RE: RESPONSE TO COUNCIL FURTHER ADVICE NOTICE AT 39 LACEY RD CARSELDINE QLD 4034 | COUNCIL REFERENCE NO. A006743933

The applicant provides the below written response to Council's Information Request dated 18 February 2026. The following documents are provided in response to Council's requests:

Figure 1: Extract of eastern boundary from Attachment A.

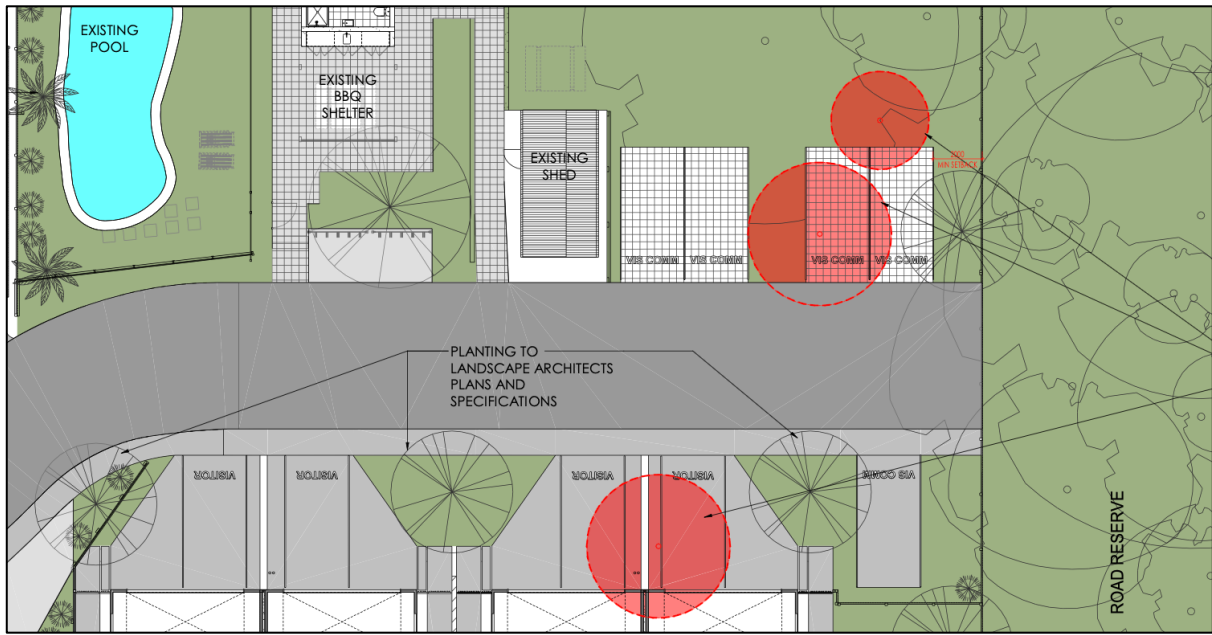
Item 3

As requested, the communal visitor car park at the eastern boundary has been relocated to provide a minimum 2m setback from the boundary.

Figure 2: Extract of refuse storage location from Attachment A.

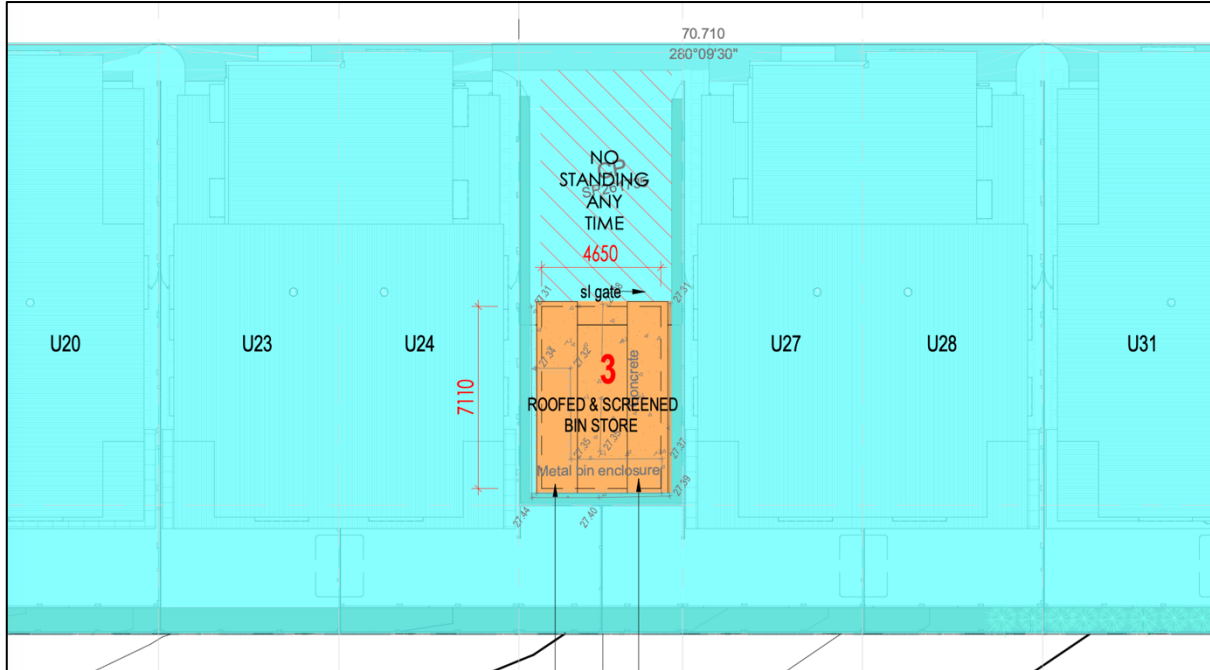
Item 5

The refuse storage area has been retained in its existing location, extended as per Council requirements and is notated to be roofed and screened. The storage area has been dimensioned to accommodate 8 x 1100LT bins.
